RE: P2P 2nd source sourcing for 19-137/R6GHBHC/S1906/2T === Harvatek

關於“minimum turn on current” 如規格書的P10.圖示 Forward Voltage vs. Forward Current

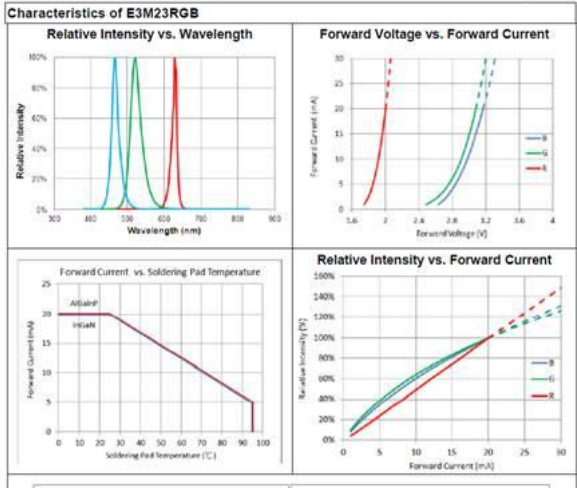
1. I think forward current too small.
Could you check to Harvatek about minimum turn on current?
=>each R/G/B color should bbe presented(R/G/B minimum turn-on current)

這題幫忙回覆下，能否幫我標註在規格書內再回傳?

0.5mA可點亮，對應VF如下

Vf-R	IF-mA
1.78	0.5
Vf-G	IF-mA
2.24	0.5
Vf-B	IF-mA
2.55	0.5

規格書上已有資訊
